TIMBER RIDGE TREE CONSERVATION PLAN TYPE II COVER SHEET

THE '02' REVISION TO THIS TCP2 IS FOR IMPACTS RESULTING FROM THE INSTALLATION OF A WATER TRANSMISSION MAIN ADJACENT TO BRANCH AVENUE WHICH WAS REVIEWED BY THE STATE, WHICH RESULTED IN REVISIONS TO SHEETS 14, 15, 20, 22, 24, 25, 26 AND 28.

TREE CONSERVATION PLAN
TYPE II
TIMBER RIDGE
PRINCE GEORGE'S COUNTY, MARYLAND (5th) ELECTION DISTRICT

DATE	1/23/04
SCALE	1" = 30'
SHEET	14
OF	28
PROJECT No.	2001190

DATE	PROJECT No.
1/23/04	2001190
SCALE	SHEET
1" = 30'	16
	OF
	28

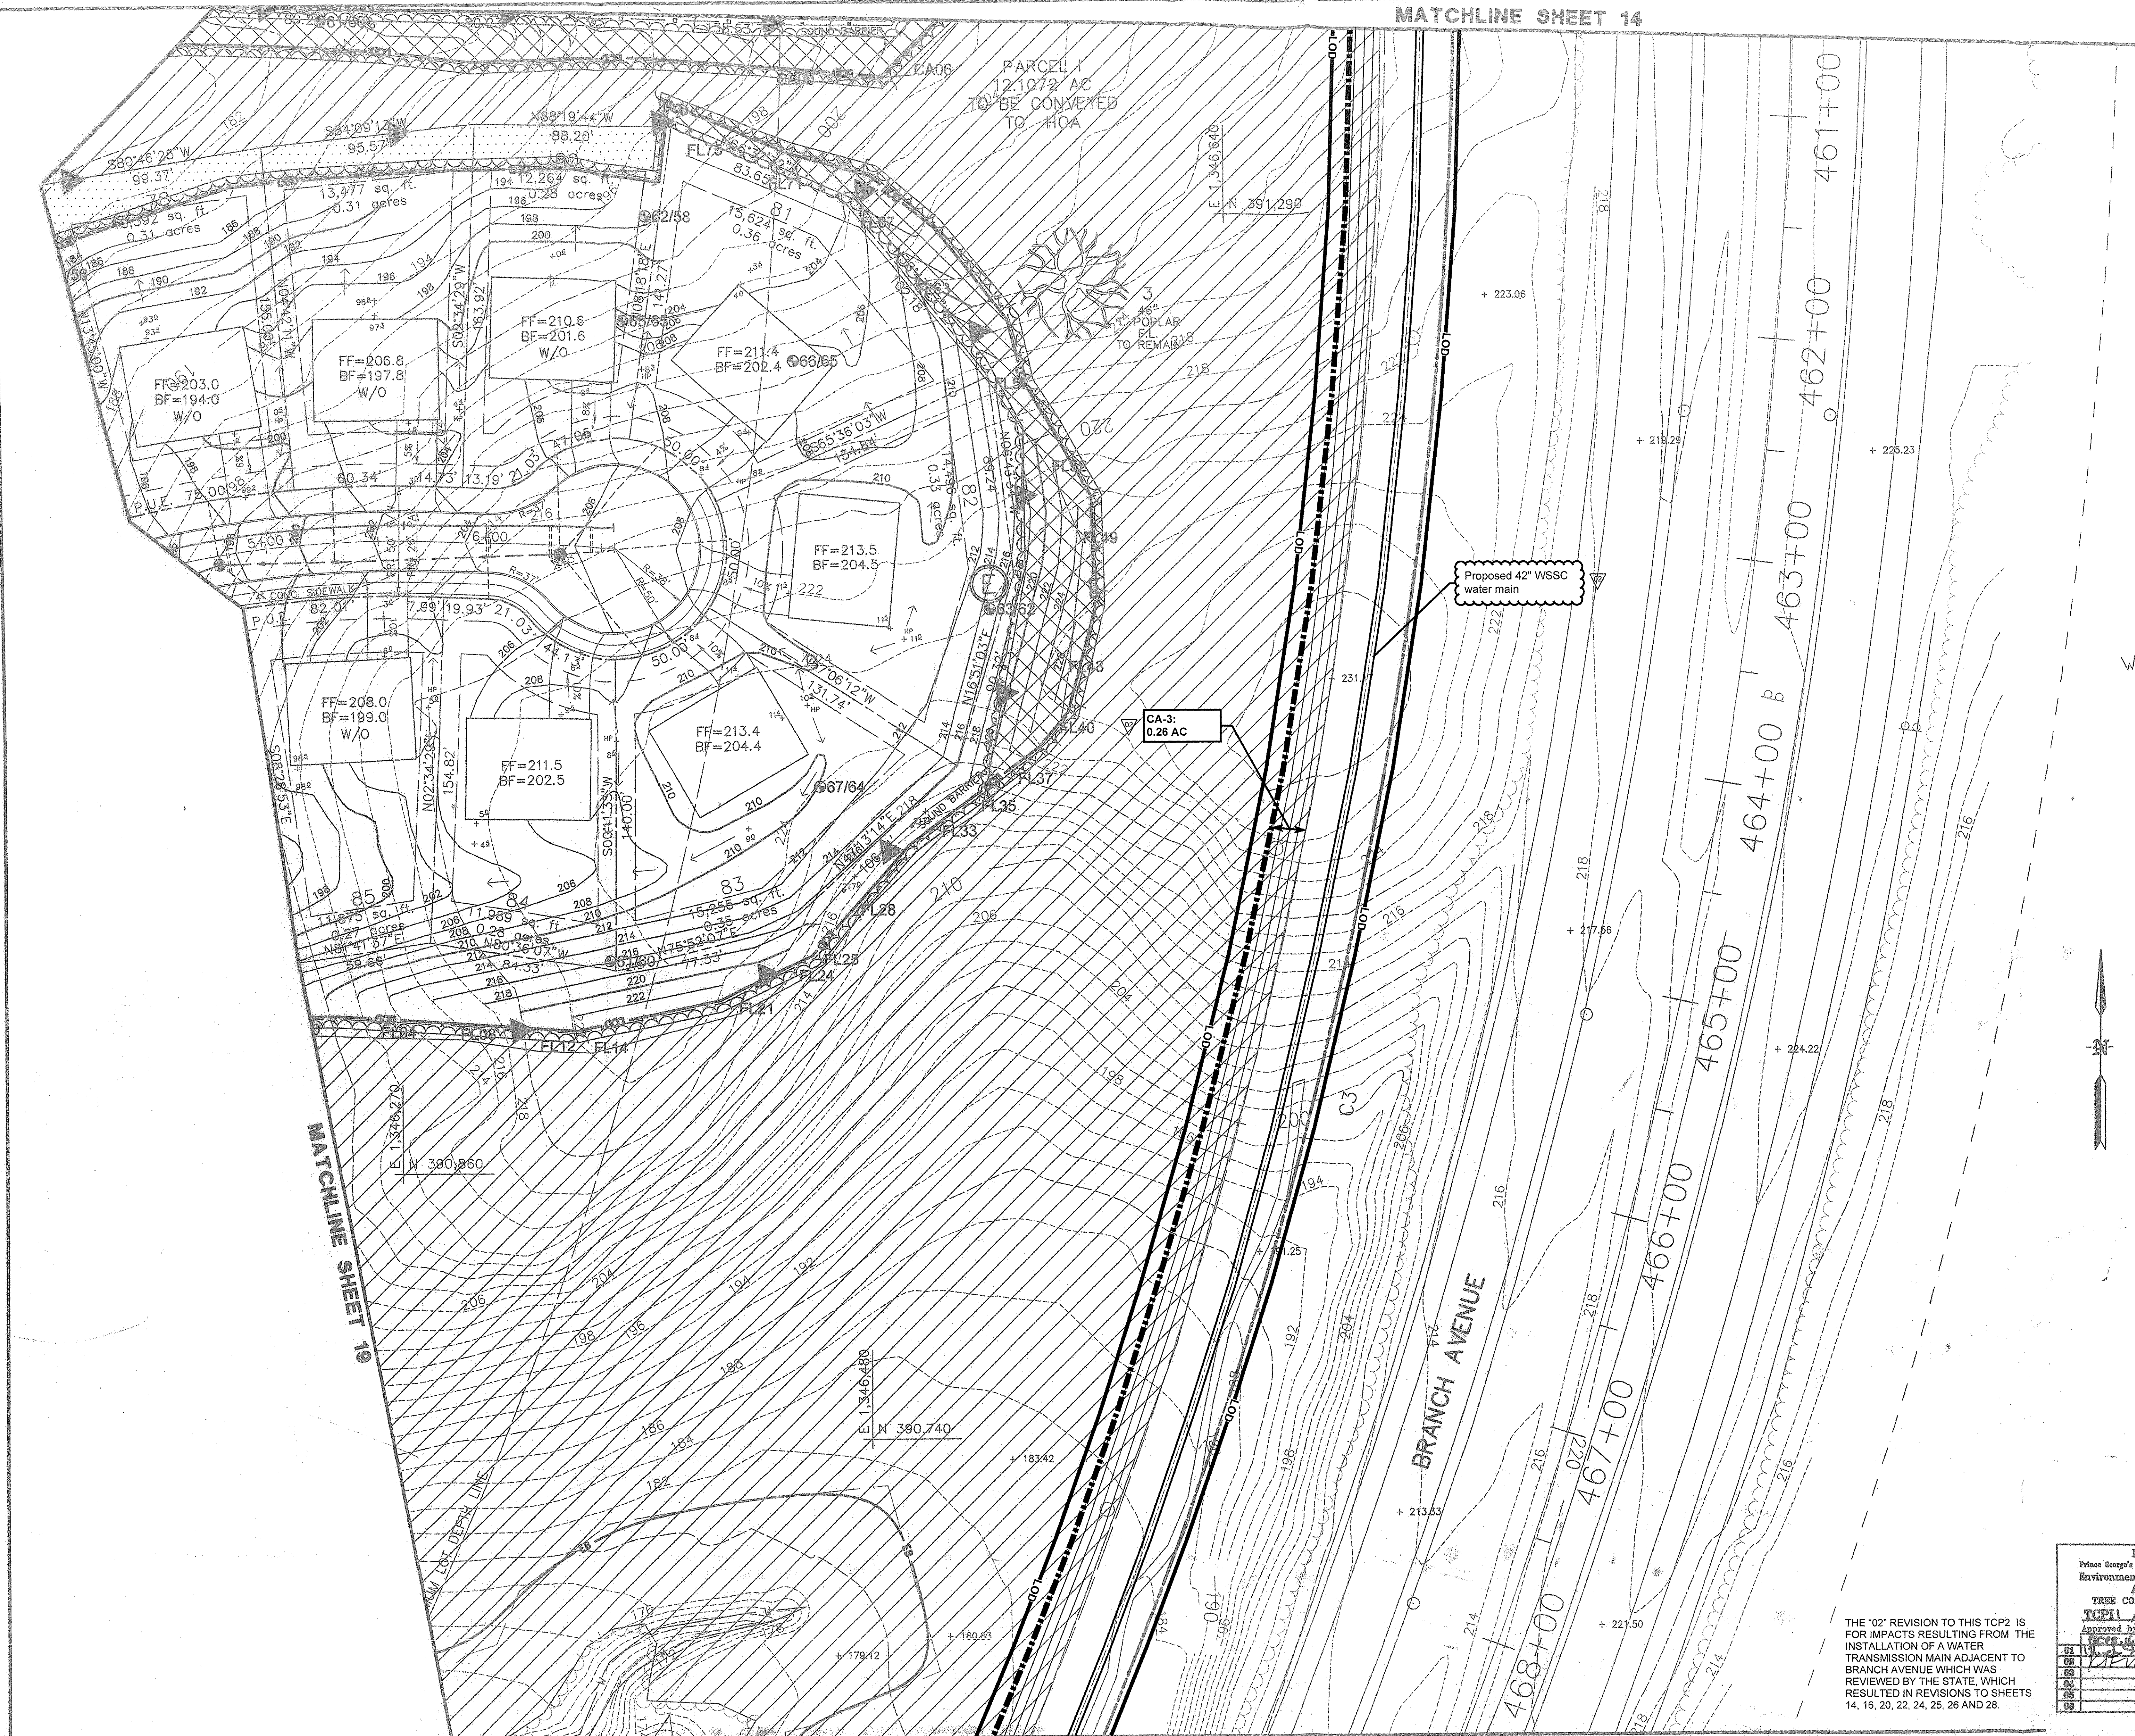
THE "02" REVISION TO THIS TCP2 IS FOR IMPACTS RESULTING FROM THE INSTALLATION OF A WATER TRANSMISSION MAIN ADJACENT TO BRANCH AVENUE WHICH WAS REVIEWED BY THE STATE, WHICH RESULTED IN REVISIONS TO SHEETS 14, 15, 20, 22, 24, 25, 26 AND 28.

DATE
1/23/04
PROJECT No.
2001190
SHEET
25
OF
28
SCALE
1" = 30'

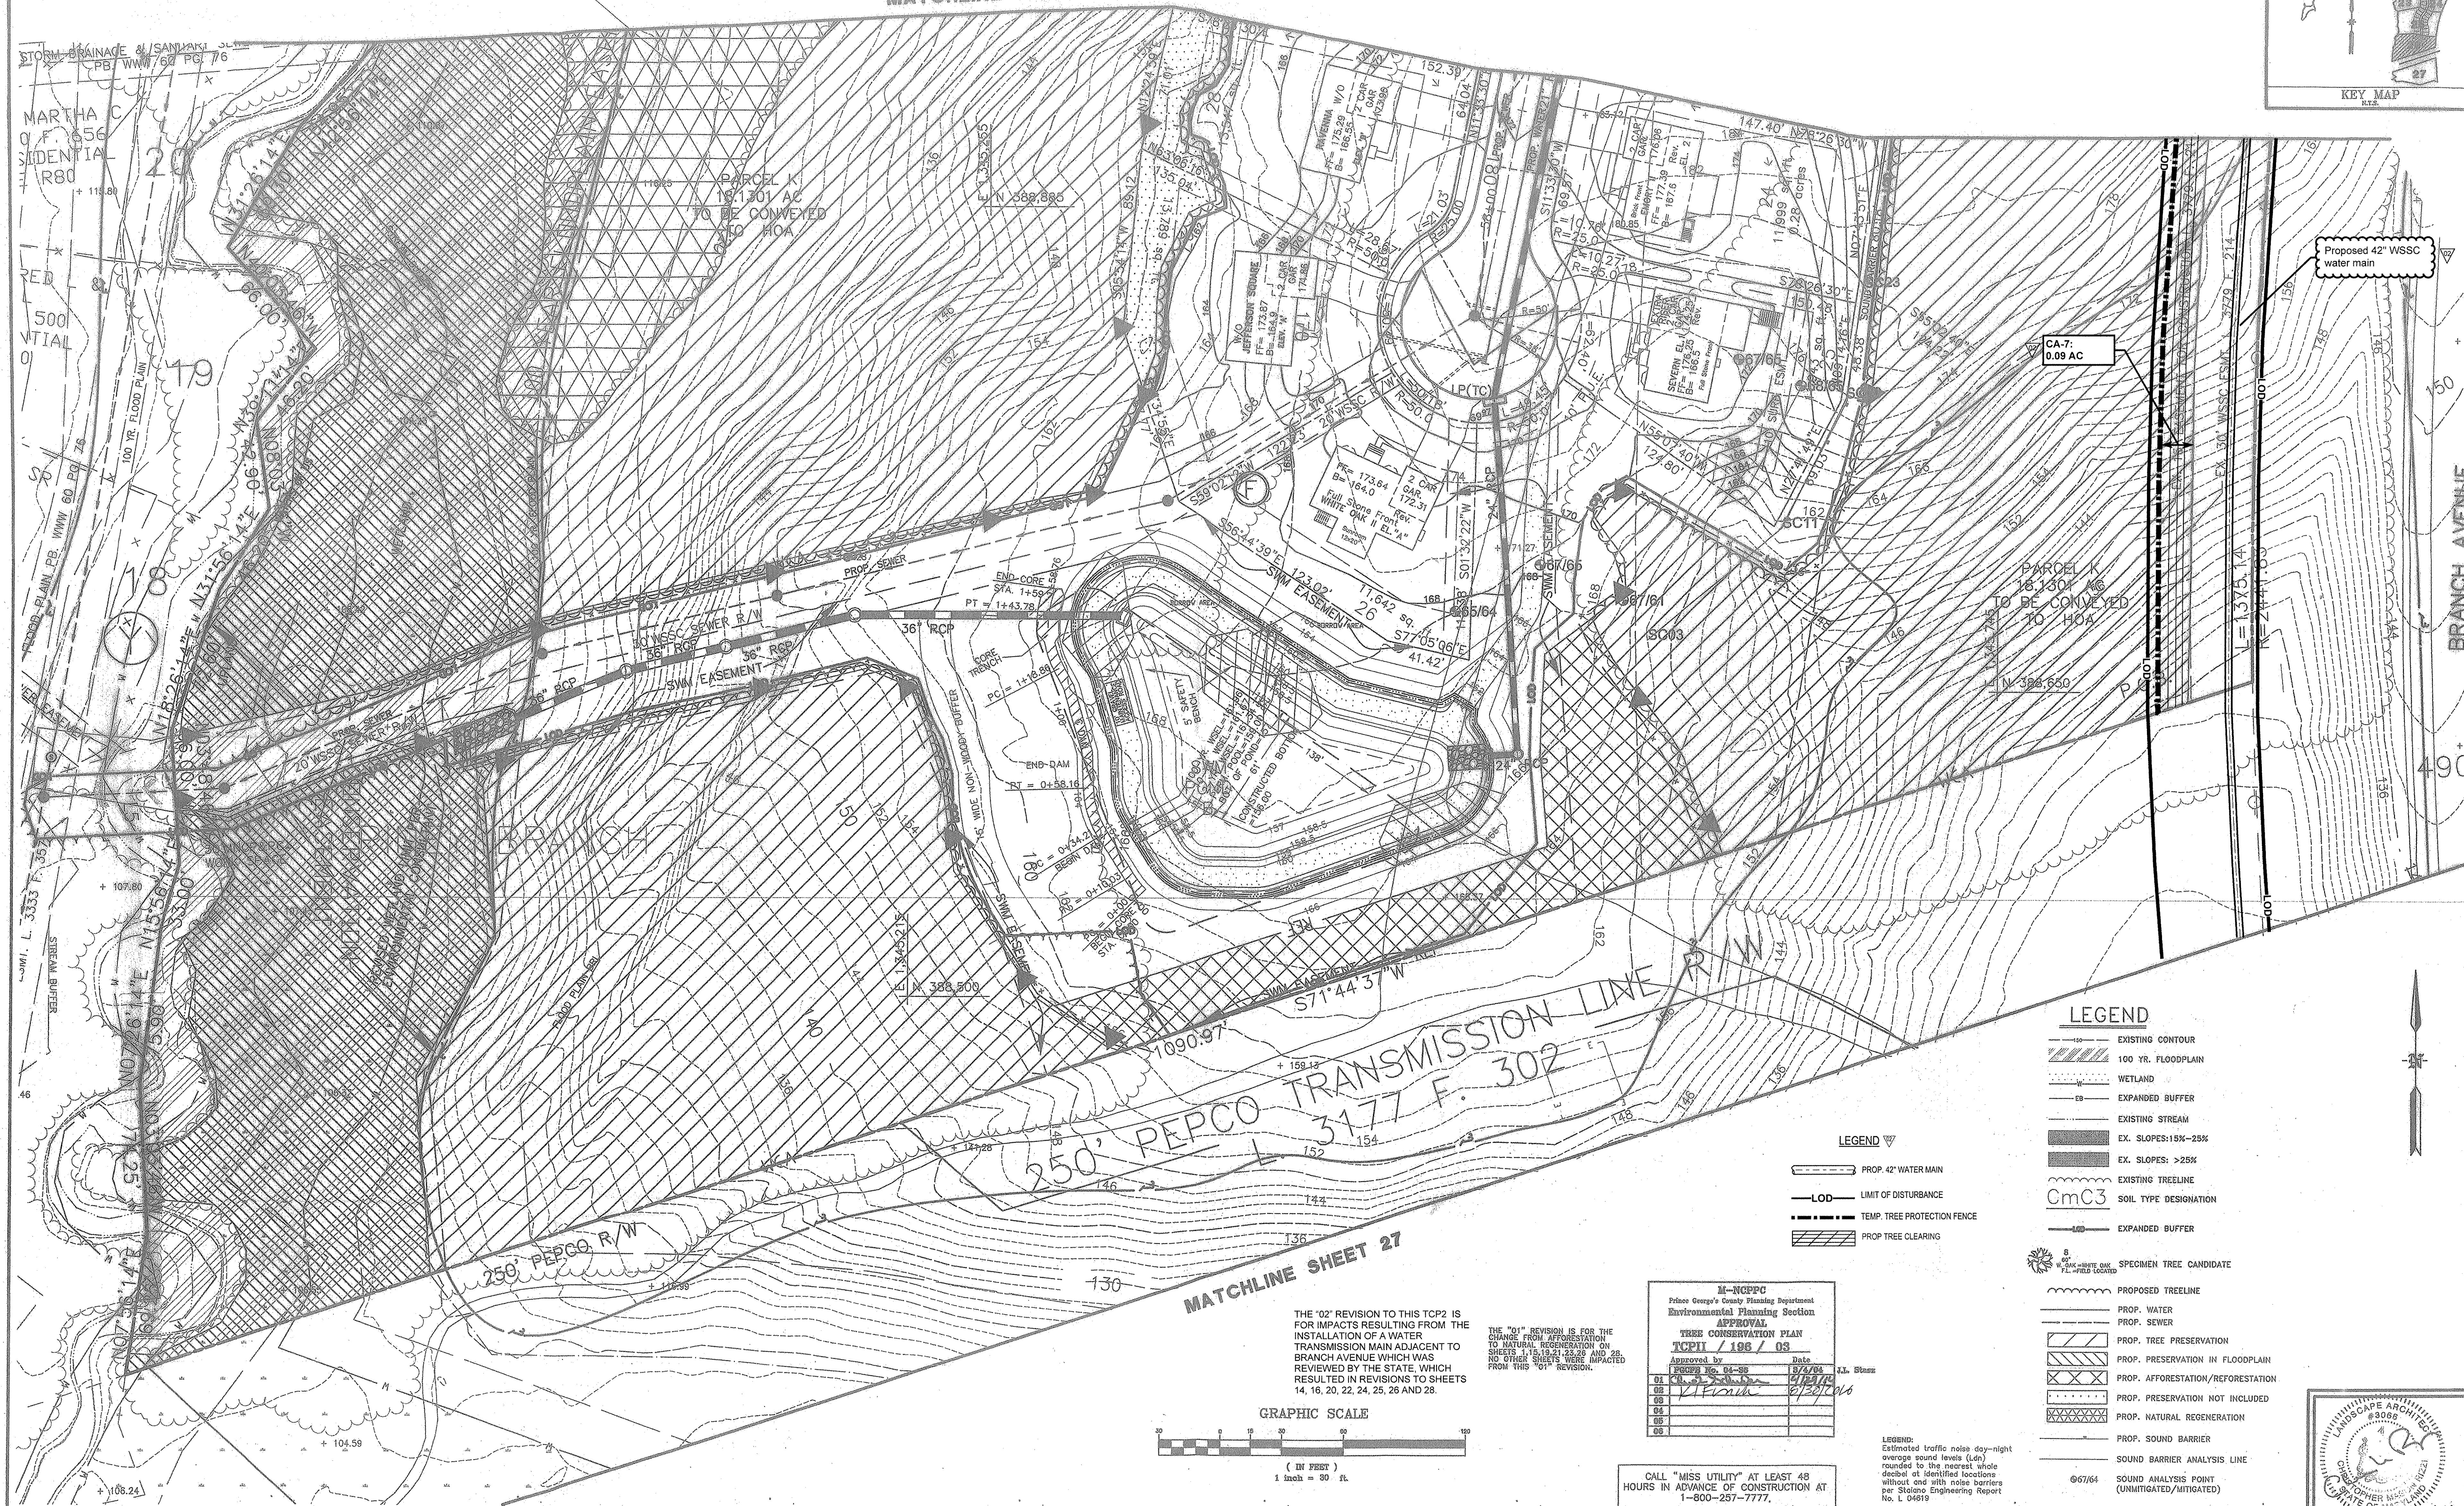
THE "02" REVISION TO THIS TOP2 IS
FOR IMPACTS RESULTING FROM THE
INSTALLATION OF A WATER
TRANSMISSION MAIN ADJACENT TO
BRANCH AVENUE WHICH WAS
REVIEWED BY THE STATE, WHICH
RESULTED IN REVISIONS TO SHEETS
14, 16, 20, 22, 24, 25, 26 AND 28.

THE "01" REVISION IS FOR THE
CHANGE FROM AFFORESTATION
TO NATURAL REGENERATION ON
SHEETS 14, 16, 20, 22, 24, 25, 26
AND 28. NO OTHER SHEETS WERE IMPACTED
FROM THIS "01" REVISION.

PROJ. MGR.	CAS	DESIGNED	GPI	DRAWN	GPI	CHECKED	LSG	DATE	REVISIONS	BY	DATE
02/16				1/16/14					REVISED FOR WATER MAIN CONSTRUCTION IMPACTS		
10/17/13				10/17/13					Added Area This Sheet ONLY Prop-Natural Regeneration Areas - West Side of "F" Block	SHD	
4/2/04				4/2/04					REVISED PER APPROVAL CONDITIONS	GPI	
1/2/04				1/2/04					REVISED PER COUNTY COMMENTS AND NOISE ANALYSIS	LSG	
									REVISIONS

NATURAL REGENERATION
AREA THIS SHEET = 0.72 AC.
